1958 Agreement - Regulations**Regulations Nos. 37 (Filament lamps) and 128 (Light emitting diodes light sources)****Proposal for Supplement 44 to the 03 series of amendments
to Regulation No. 37 (Filament lamps)****Submitted by the expert from the International Automotive Lighting
and Light Signalling Expert Group (GTB)***

The text reproduced below was prepared by the expert from the GTB to introduce new halogen categories H18, H19 and H20 and some minor corrections to existing categories. The modifications to the existing text of the Regulation are marked in bold for new or strikethrough for deleted characters.

Sheet PR21/5W/1, the following drawing,
 “

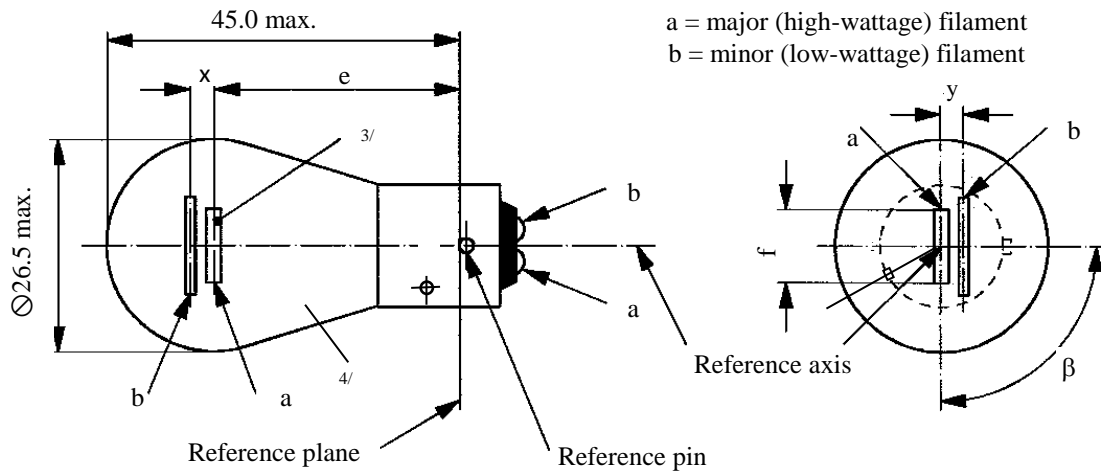
amend to read:

- Category H1; on sheet H1/1 note 2 the term “electrode” is amended by “leg”.
- Category PR21/5W; GTB considers it necessary to improve the drawing to avoid confusion and requests advice from the secretariat whether this part of the proposal should be split off and progress as a corrigendum to Revision 6 and to Revision 7.

“2.4. Restricted colour boundaries.

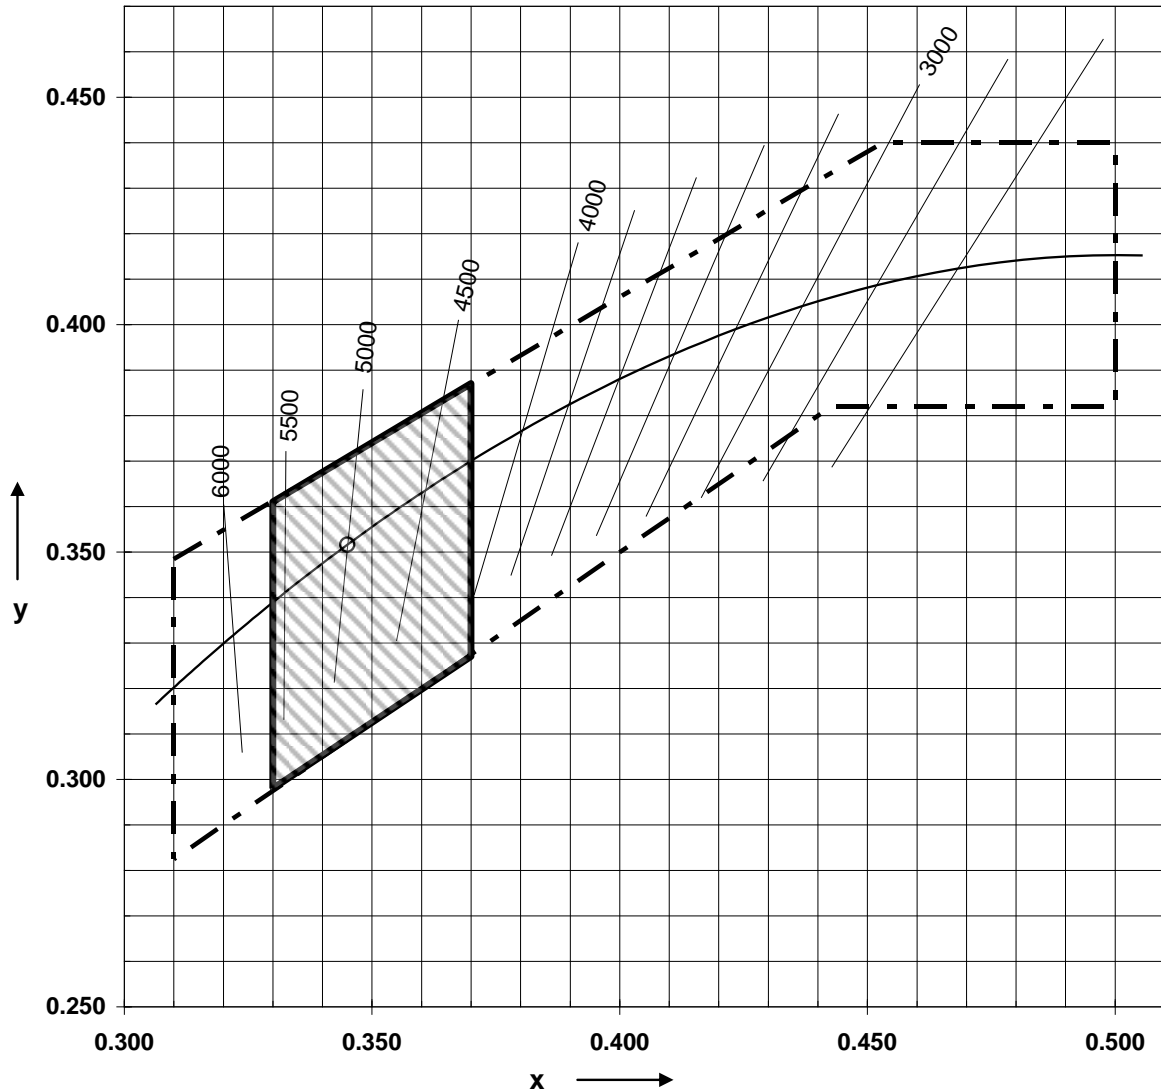
Annex 5, insert a new paragraph 2.4, to read:

The following figure shows the colour tolerance area for the colour white (within the dashed lines) and the restricted tolerance area for the filament light source H20 (shaded area within the solid lines) in the CIE chromaticity coordinate system (x, y).
